RATIONALE

BOLT, MACHINE, DOUBLE HEX, EXTENDED WASHER HEAD, CLOSE TOL. SHANK, UNS N07718, 185 KSI MIN .3750-24 UNJF-3A (STRESS RUPTURE RESISTANT)

AS3420™
SHEET 1 OF 3

REV. C

FIGURE 1 - BOLT

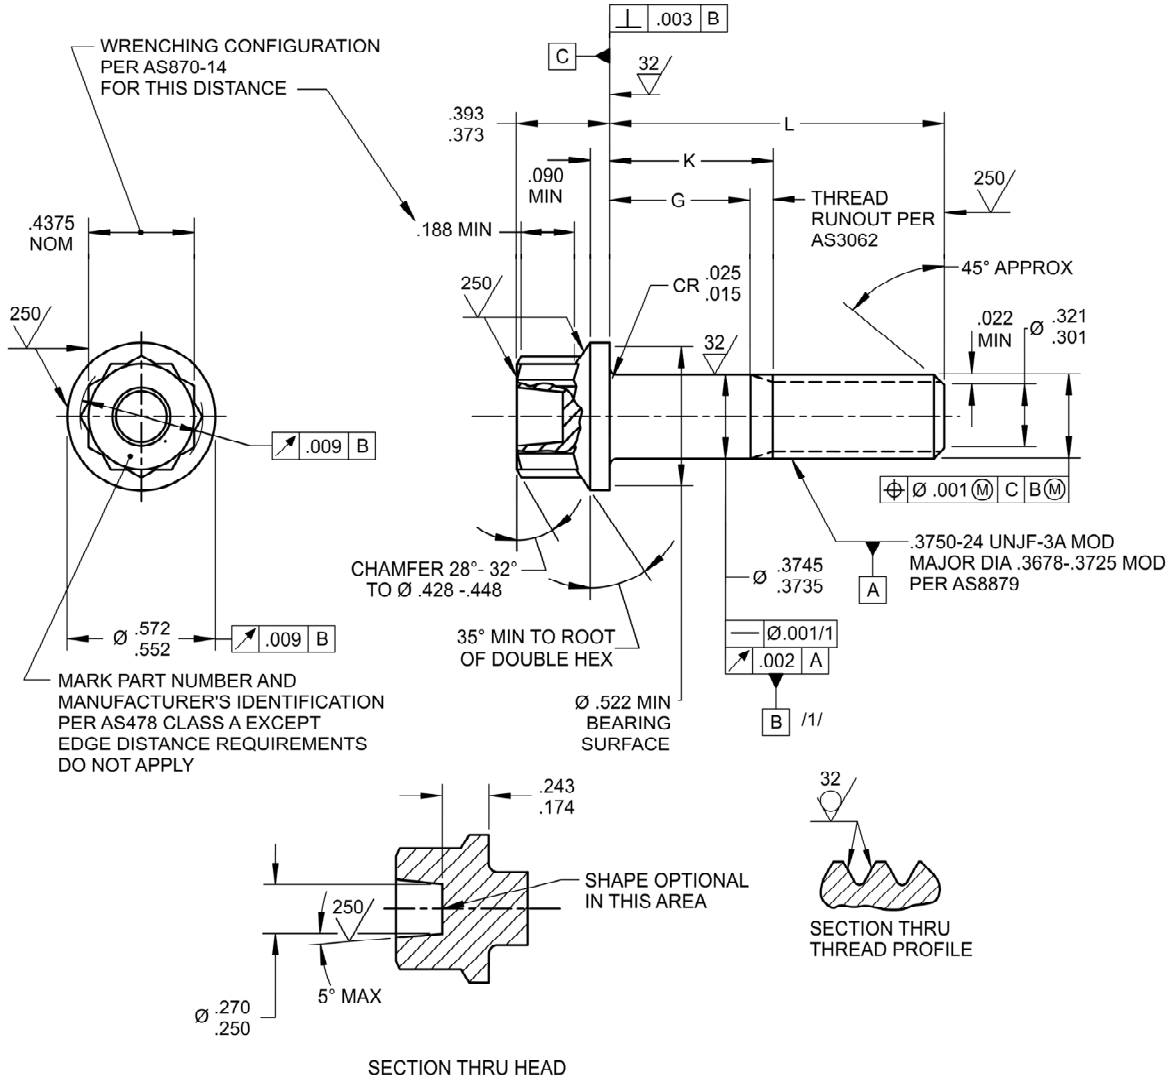
UPDATE TO ASME Y14.5-2018. UPDATE LEAD THREAD CHAMFER TO AS1132. REVISE POSITION FCF ON MAJ DIA TO INCLUDE NEW DATUM C PER AS1132. REVISE LIGHTENING HOLE CONFIGURATION TO AS1132. REVISE HEAD TO SHANK FILLET TO CR. ADD "COMPOSITION SIMILAR TO" TO UNS IN NOTE 2. GENERAL EDITORIAL UPDATES.
